APICAL INDUSTRIES, INC.
dba DART AEROSPACE

ENGINEERING CHANGE NOTICE NO. 05397		SHEET 1 OF 1	
DWG NO. 647.7700	REV: A	PREPARED BY T. CROSS	DATE: 05/02/16
EFFECT ON DWG ☐ INC. ☒ UNINC.			
DWG TITLE: STRUT ASSY			
APPROVED BY: ENGR <i>[Signature]</i>	MFG <i>[Signature]</i>	QC <i>[Signature]</i>	EFF: <i>[Signature]</i>
REASON: REVISED DIMENSION			CURRENT ORDER
TRANSACTION CODES (TC): A-ADD C-CREATE R-REVISE D-DELETE			ECR: 16-028

ENGINEERING CHANGE NOTICE NO.

DWG TITLE: STRUT ASSY

SHEET 2, ZONE D4 IS:

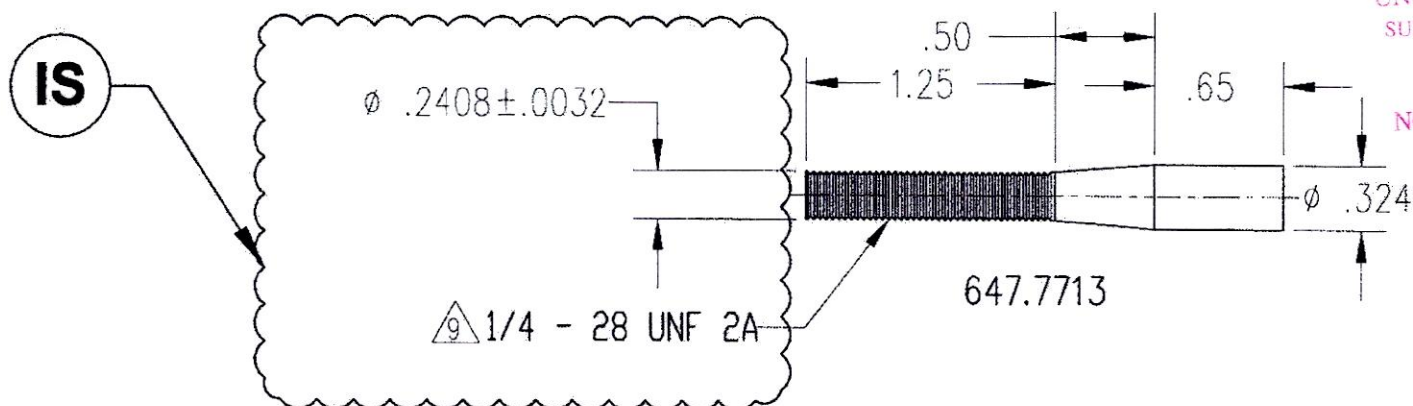
ACTION LIST:
1.

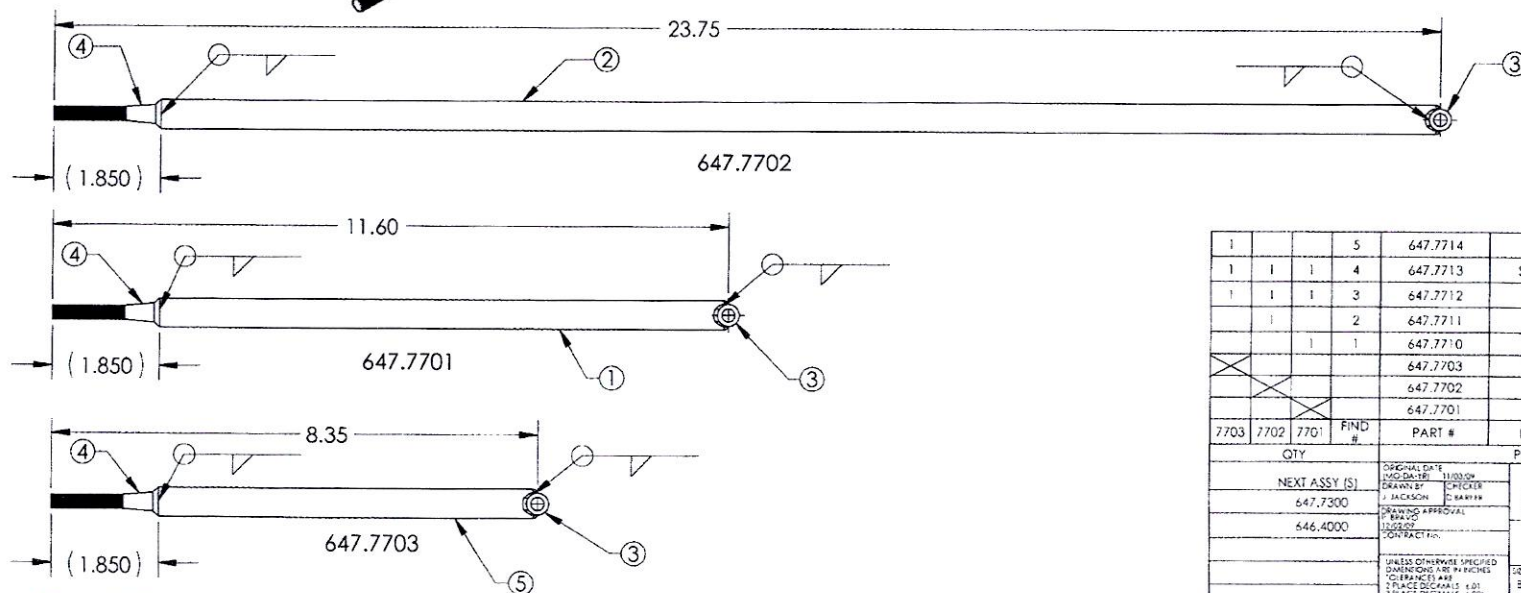
REASON: REVISED FINISH CALLOUT AS PER ECR 15-209

SHEET 1, NOTES IS:

- 1 MATERIAL: 4130 STEEL PER AMS-T-6736, .50" OD, .083" WALL THK.
- 2 MATERIAL: 4130 STEEL PER AMS-T-6736, .375" OD, .075" WALL THK.
- 3 MATERIAL: 4130 STEEL PER AMS-T-6736, .324" OD.
- 4 FINISH: PRIME IAW MIL-P-2337J TYPE I CLASS N; 1-2 MIL MAX
5. DEBURR AND BREAK ALL SHARP EDGES
6. IDENTIFY IAW MPP-120.
- 7 WELD IAW MIL-STD-2219. TIG WELD WITH FILLER ROD
- 8 FINISH: CAD PLATE IAW QQ-P-416F CLASS I TYPE II
- 9 MASK THREAD PRIOR TO FINISH
